CONFORMED SET

LEVEL 01 AREA A FLOOR
PLAN

Project No.: 04561.01

A0101.A

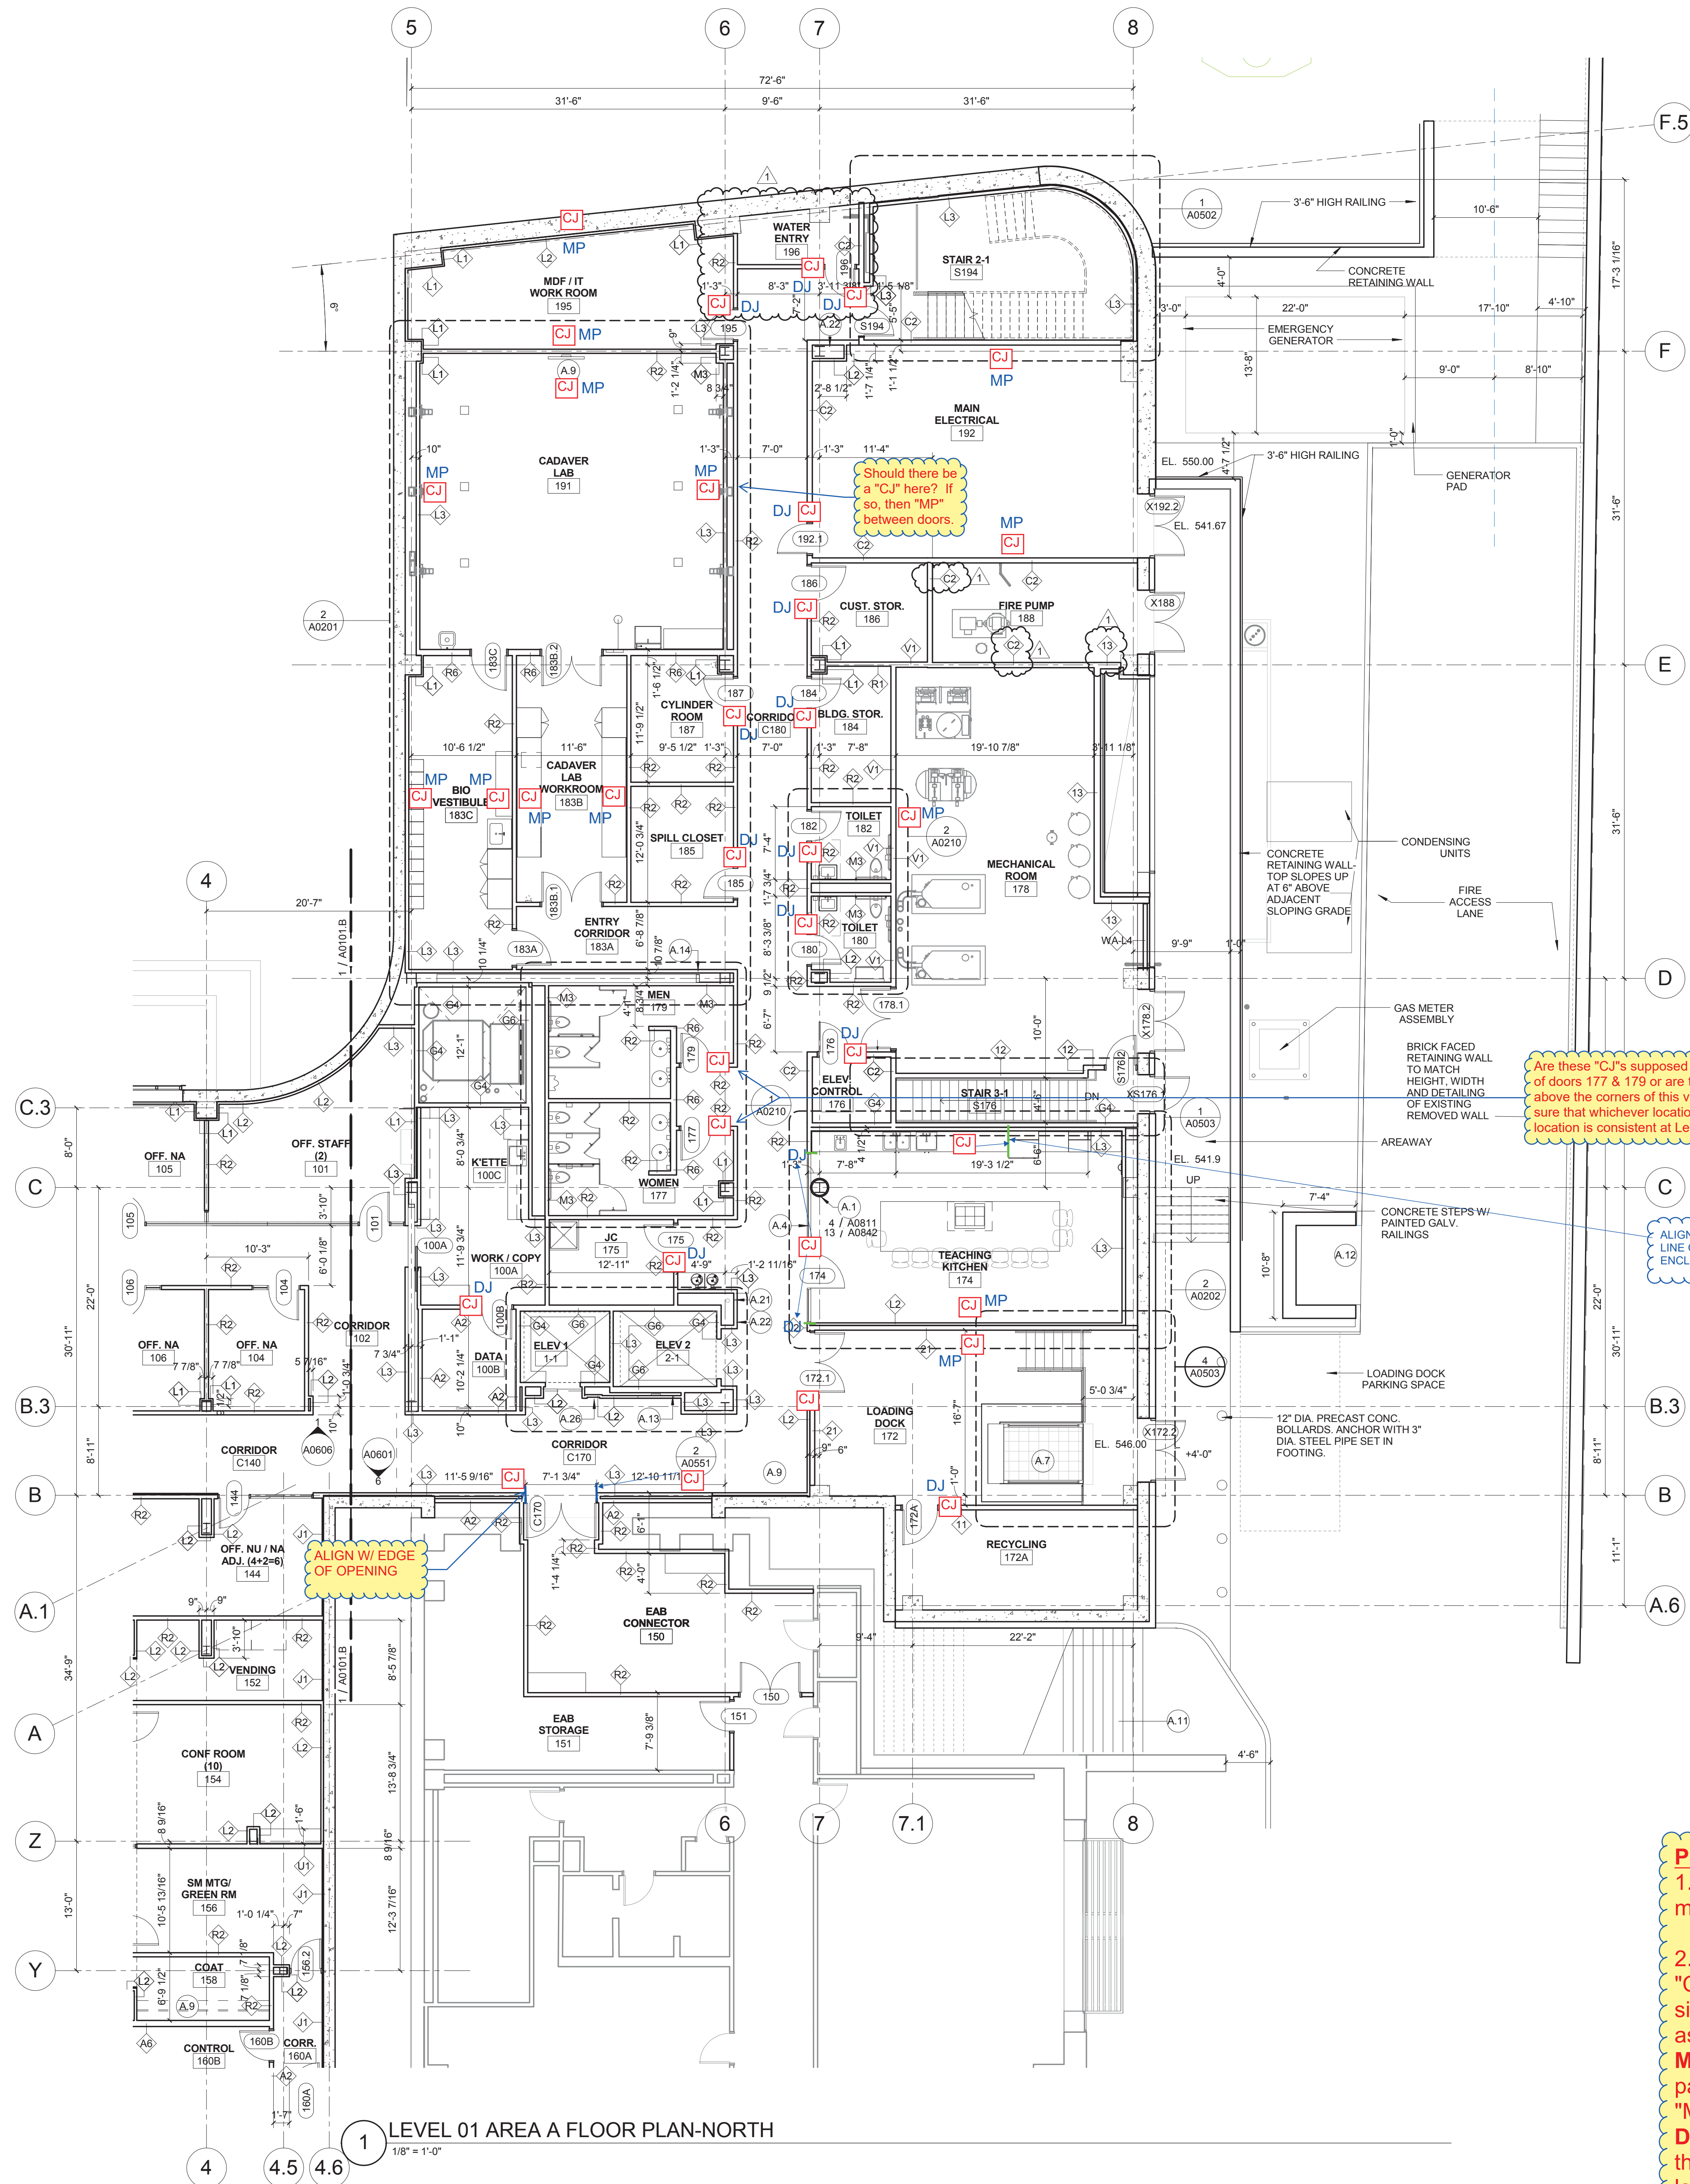
Control Joints to be installed per
092900-3.5.B and ASTM C 840

Partition Control Joint Notes:

1. All partition acoustical (stc) ratings and/or fire ratings must be maintained if a control joint is installed in them.

2. It is assumed that where ever there is a box with a "CJ" in it, that there is to be a control joint only at one side of the partition that this "CJ" box is next to. If this assumption is correct, then:

MP = Locate this control joint at the mid-point of this partition on the side of the partition that this abbreviation "MP" is located.

DJ = Locate this control joint above the door jamb on the side of the partition that this abbreviation "DJ" is located.

A0102.B

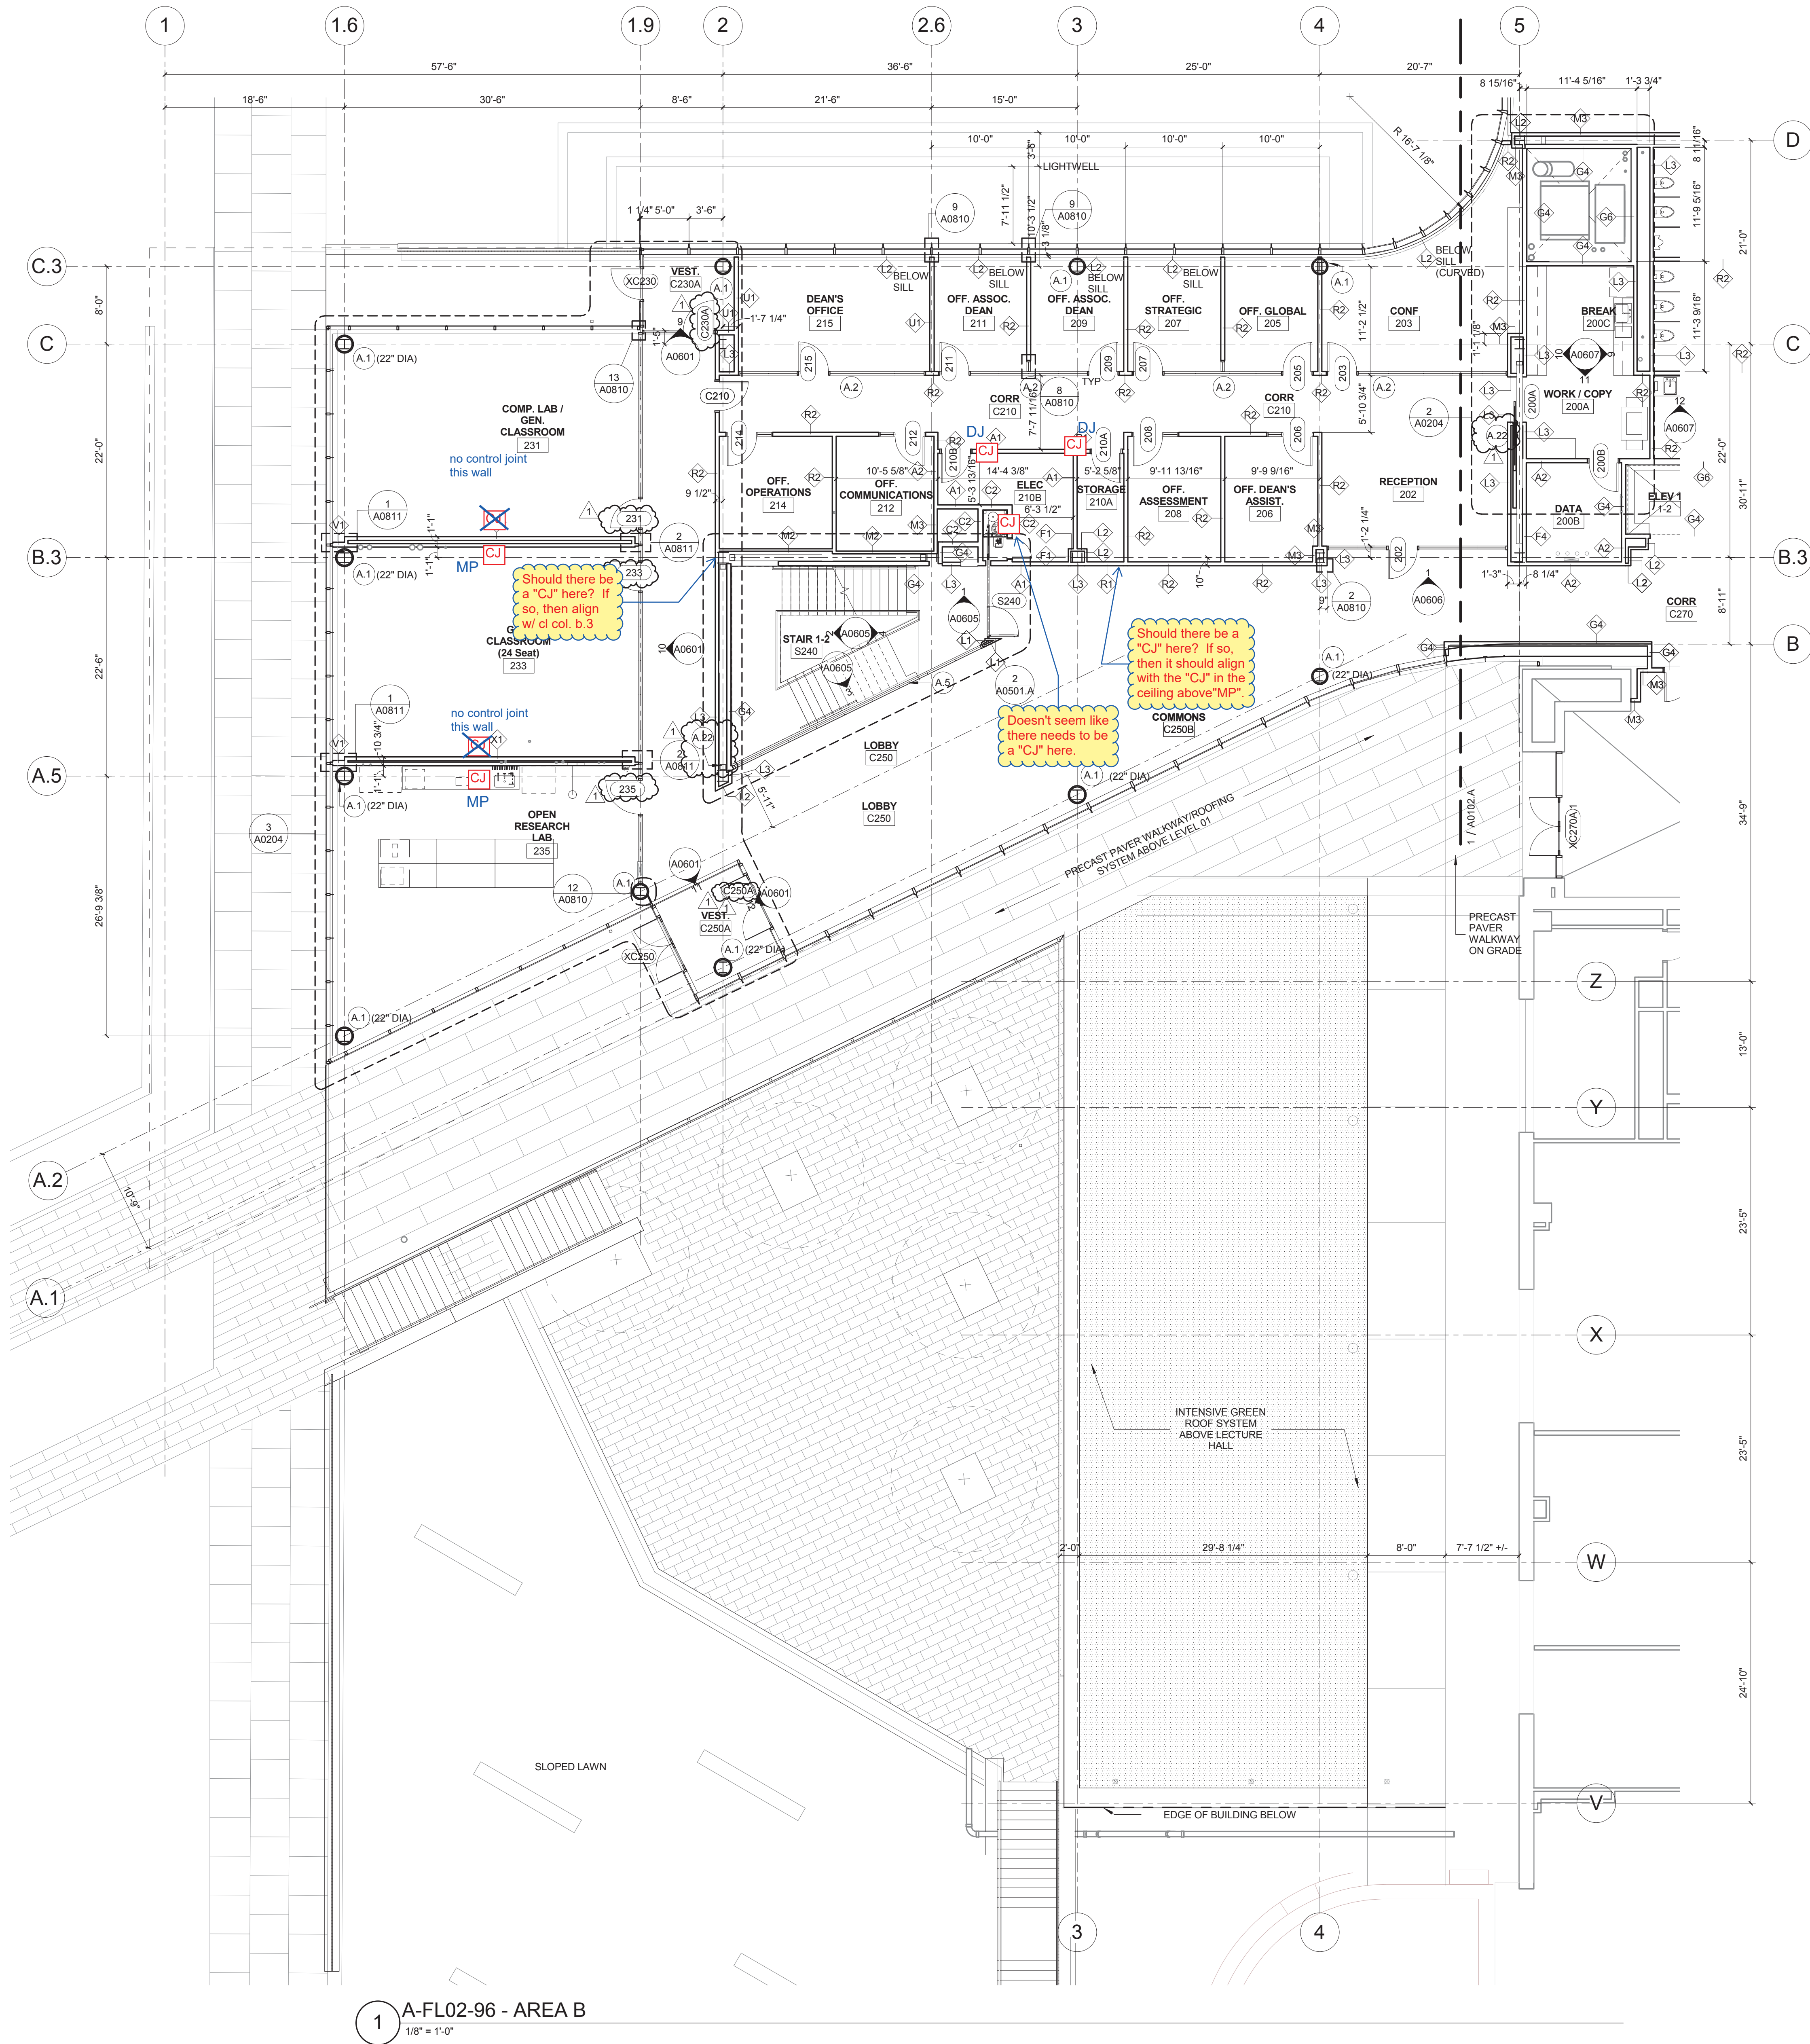
It is assumed that this "CJ" is to align with the edge of the opening across the corridor (and the "CJ" in the ceiling above).

align with edge of opening

Are these "CJ"s supposed to be above the jambs of doors 277 & 279 or are they supposed to be above the corners of this vestibule / alcove? Make sure that whichever location is required, that location is consistent at Levels 2, 3, & 4.

A0103.A

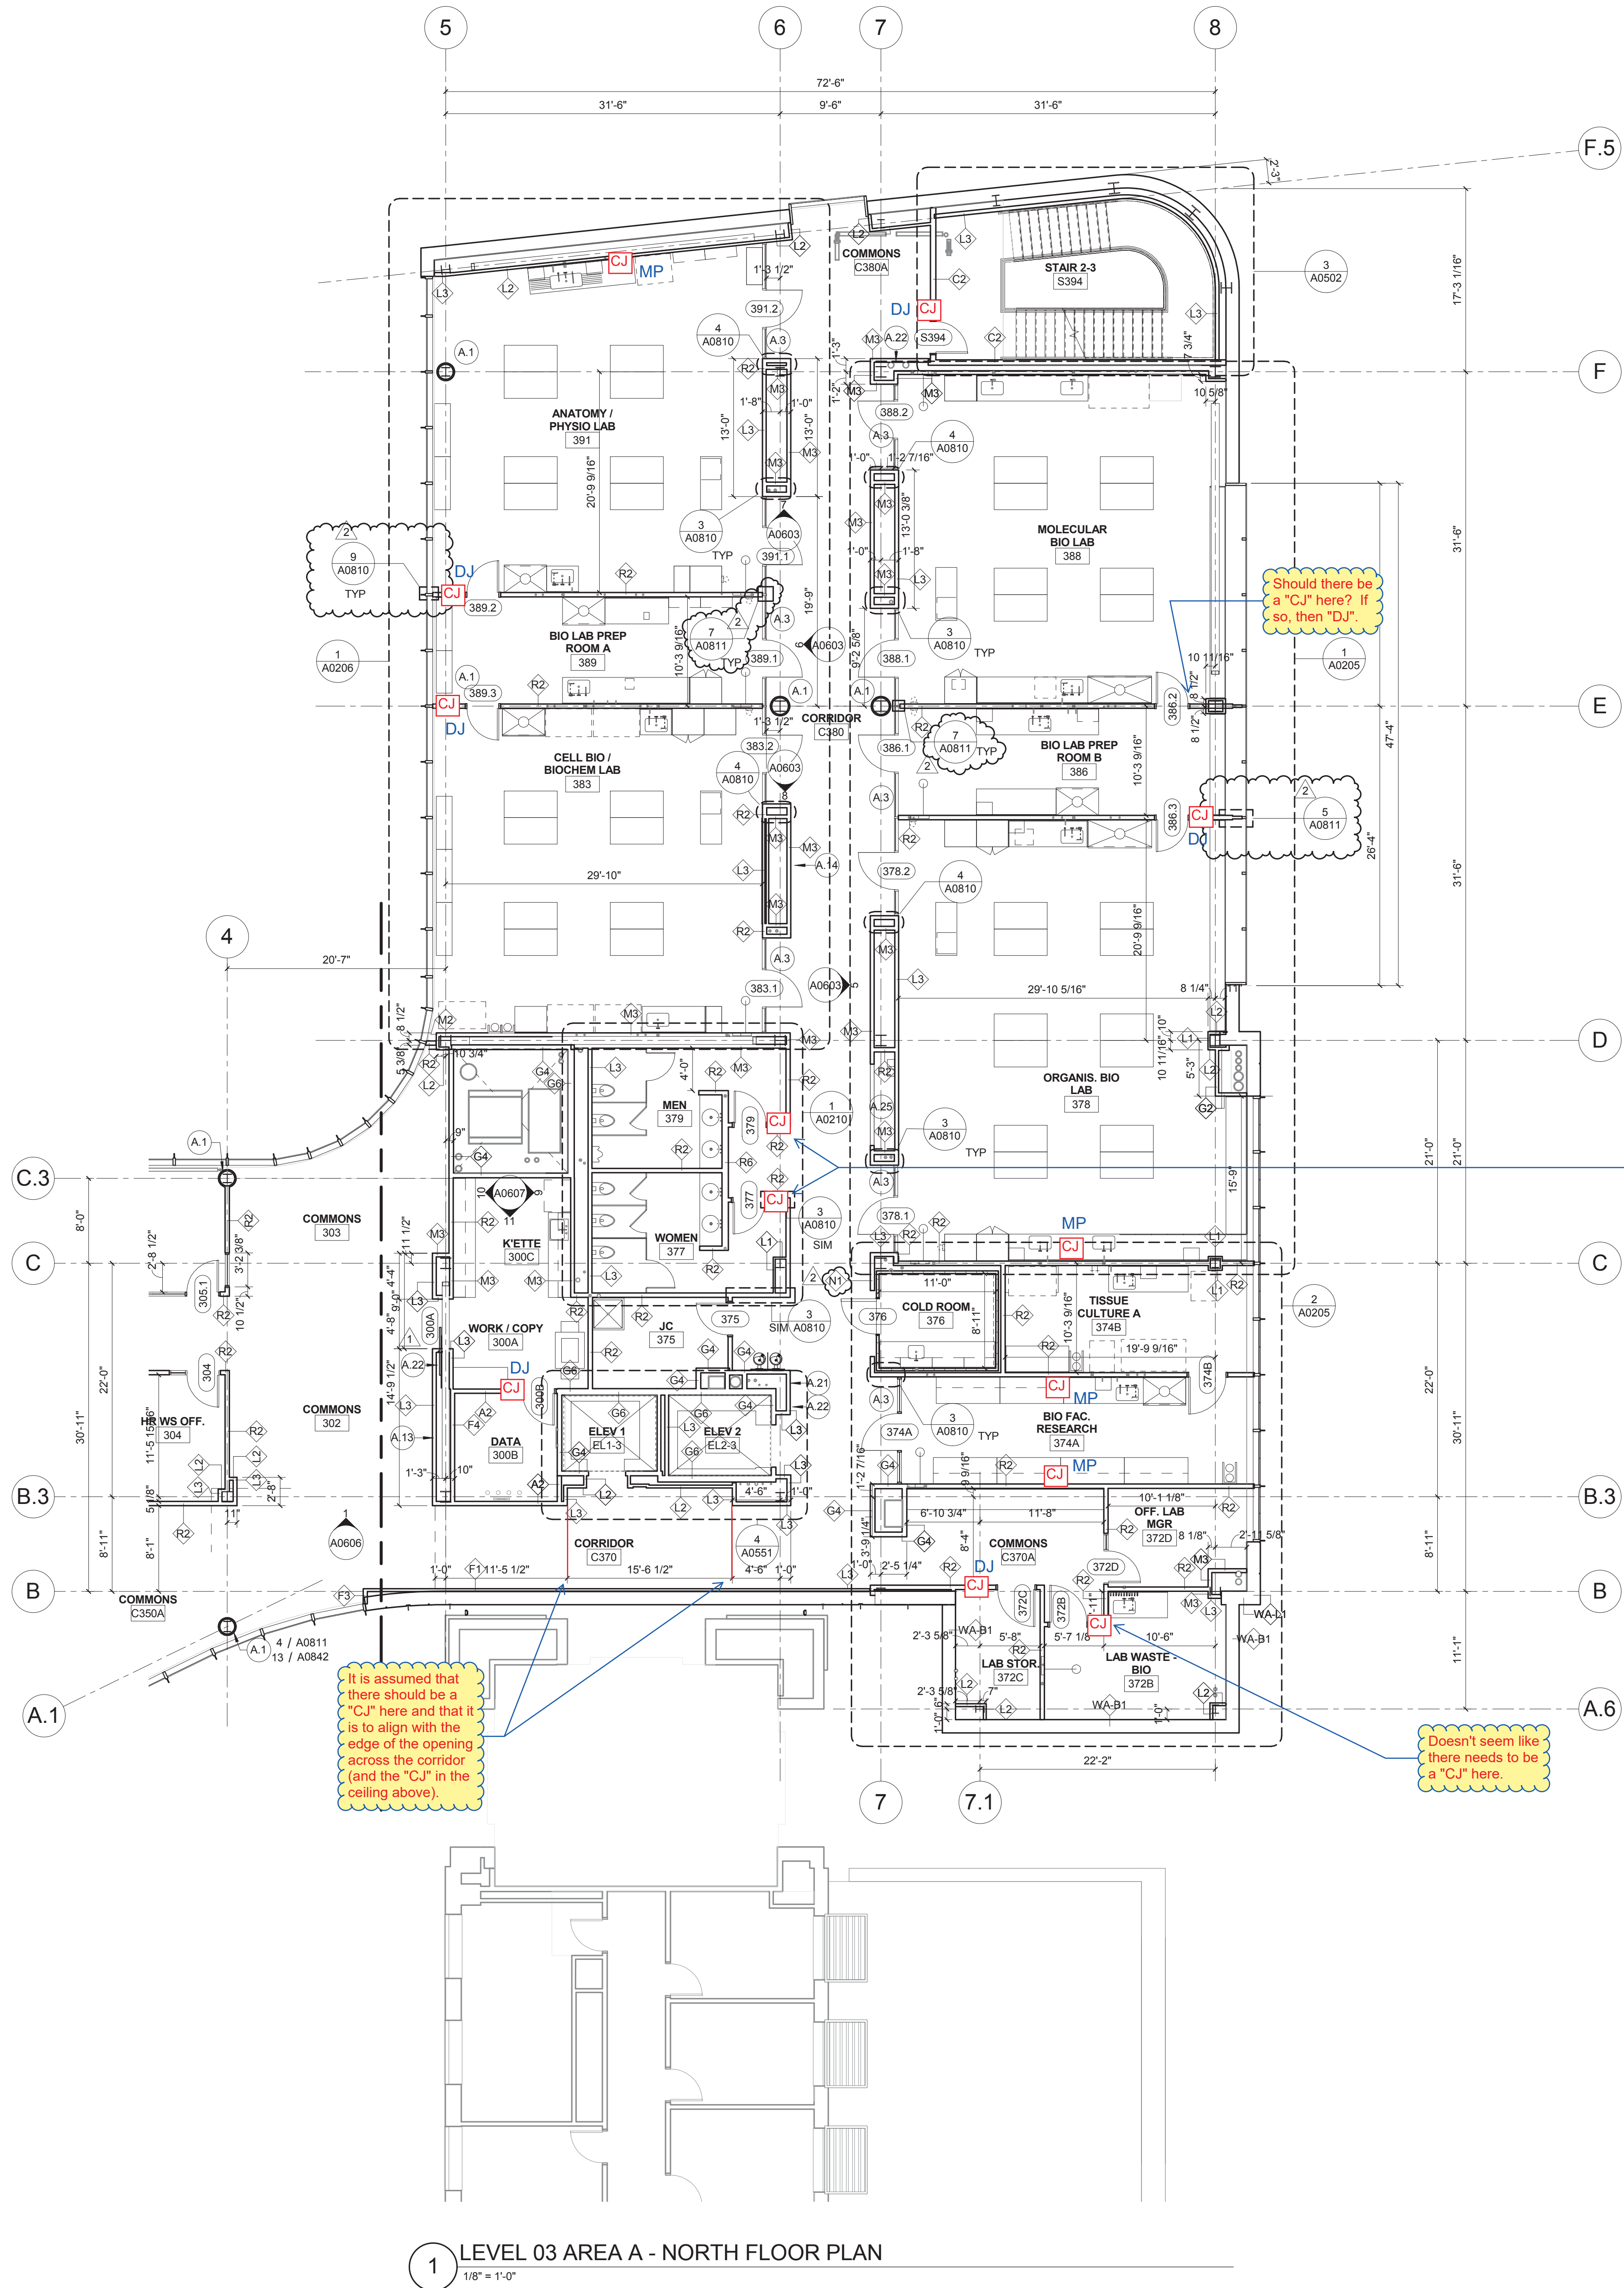
Should there be a "CJ" here? If so, then "DJ"

Are these "CJ"s supposed to be above the jambs of doors 377 & 379 or are they supposed to be above the corners of this vestibule / alcove? Make sure that whichever location is required, that location is consistent at Levels 2, 3, & 4.

It is assumed that there should be a "CJ" here and that it is to align with the edge of the opening across the corridor (and the "CJ" in the ceiling above)
